REQUEST FOR COUNCIL ACTION

AGENDA SECTION: PUBLIC HEARINGS	ORIGINATING DEPT: PLANNING	E-6
ITEM DESCRIPTION: Land Subdivision Permit (Prelimina Maine Street Development by Maine Street Development Applicant is proposing to subdivide approximately 104.3 commercial-industrial development and 8 Outlots. The Public roadways. The applicant is also requesting approach Alteration to permit site grading that will modify grades to the property. The property is located east of TH 63, north future alignment of St. Bridget Road SE.	Company of Rochester LLC. The 4 acres of land into 13 lots for Plat also proposes to dedicate new oval of a <i>Substantial Land</i> by more than 10 feet on portions of	PREPARED BY: Brent Svenby, Planner

Preliminary Plat Approval

Land Subdivision Permit (Preliminary Plat) #03-11 to be known as Maine Street Development by Maine Street Development Company of Rochester LLC. The Applicant is proposing to subdivide approximately 104.34 acres of land into 13 lots for commercial-industrial development and 8 Outlots. The Plat also proposes to dedicate new public roadways. The applicant is also requesting approval of a Substantial Land Alteration to permit site grading that

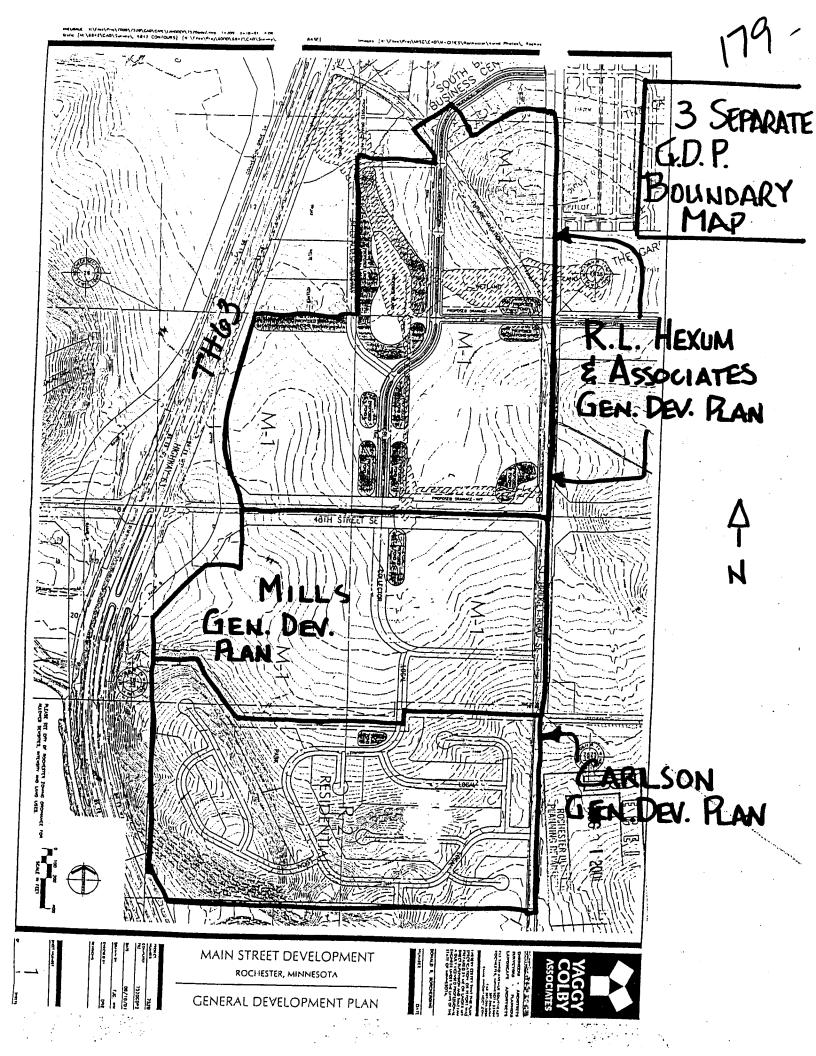
Proposed changes to conditions of approval:

- 8. The State has already acquired the necessary right of way for the reconstruction and capacity improvements planned for St. Bridget Road SE and, 48th Street SE and 48th Street SE/T.H. 63 interchange. The Owner's proportionate share of the City's and County's share of the costs related to right of way and construction (including pedestrian facilities) will be addressed in an amended Development Agreement.

- 9. Pedestrian facilities must be provided along the entire frontages (including Outlots) of both sides of all new interior public roadways.
- 11. The Applicant is responsible to construct a private roadway within Outlot B and Outlot D, pursuant to the terms of an agreement between the Applicant and the owners of the abutting parcels, and must extend utilities (water and electrical) to serve the abutting parcels. An access easement must be recorded over Outlot B and Outlot D for ingress/egress to the abutting parcels, pursuant to the agreement of the parties. The easement documents must be recorded prior to recording the Final Plat and the Final Plat documents must be revised to identify the access easements and document numbers. The easement documents shall be perpetual, establish a clear policy on how maintenance will be handled, establish the rights of usage, and define how use of the easement is limited or assignable. Public safety personnel and their vehicles shall be assigned the right of passage at all times.

NOTE: In discussions with the City Engineer, staff is not agreeable to the recommended changes to conditions 8, 9 and 11 as presented by Mr. Ryan and recommends that the City Council adopt the conditions as suggested in the staff report. On condition 11, which requires an access easement provided for Lot 2, Block 5, reference to that can be removed because a Declaration of ingress and egress has already been recorded for the property. Staff would be agreeable with the changes suggested by Mr. Ryan if the language shown in capital letters is included.

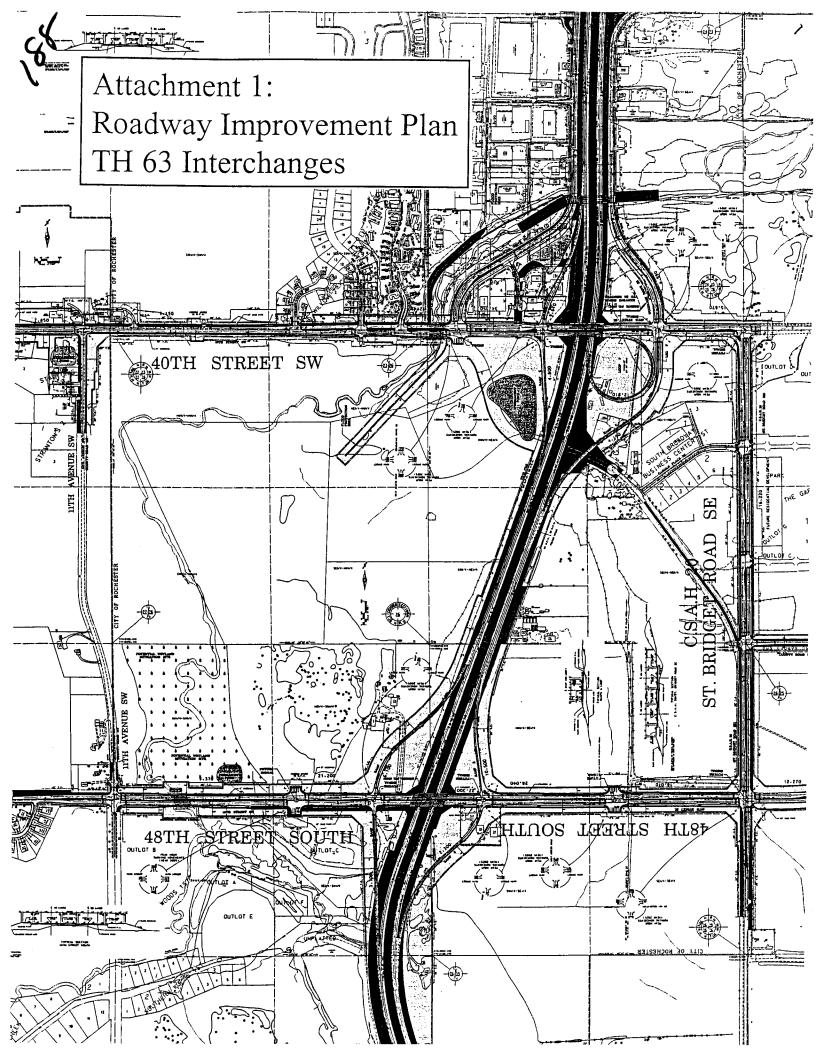
• The critical issue which the supplementary analysis identified was the need for additional lanes at the intersection of 48th St SE with the proposed Maine Street, which is the proposed access into the site off of 48th St. The analysis identified that with the proposed level of development, a 2nd eastbound left turn lane (for the eastbound left turn north into the site) would be needed. In addition, the analysis also identified the need for 3rd westbound lane between the Maine Street / 48th St intersection and the East Ramps

at the interchange, to handle a heavy anticipated flow out of the development site back to TH 63.

- The access locations on St Bridget's Road will have relatively heavy eastbound to northbound left turn flows exiting the development as well. At these intersections, a design utilizing a dedicated left turn lane along with a second shared left turn / thru lane will be needed.

- Internal to the site, there is an access proposed to serve Lot 1, Block 1 and Lot 1, Block 7 approximately midway between 48th St and the internal intersection of Maine Street and Canal Drive. This intersection will need to be limited to a ¾ type access that permits right-in, right out traffic as well as left turns into Lot 1 of Block 1, but not left turns out of the lots onto Maine Street. Further evaluation of the intersection design will be needed at the time public improvement plans are prepared for these street sections.

- It is anticipated that future signalization will be required at both locations where Canal Drive intersects Maine Street. These intersections will be four-legged intersections, with the fourth leg serving as the primary exit locations for the development on Lot 1, Block 7, and Lot 5, Block 6 respectively.
